2015 - 2016 Corvette: Service Bulletin:

#16-NA-014: Delayed Engagement After Sitting

#16-NA-014: Delayed Engagement After Sitting With Engine Off - (Jun 28, 2016)

Old stator support asm New stator support asm

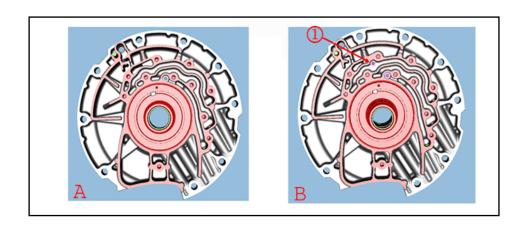
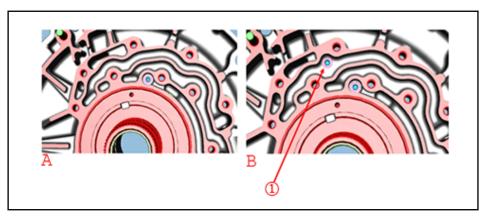
Note: The new stator shaft support assembly has a second check ball (1) added (see illustrations).

Install a new stator shaft support assembly that includes an additional check ball. Follow the instructions below to replace the stator shaft

Old cover - 8L90 Only New cover - 8L90 Only

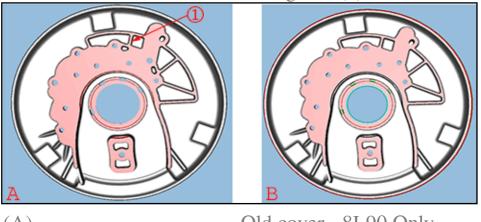
Note: The casting void has been eliminated from the underside of the cover for the 8L90 only (see illustration). The 8L45 is not required.
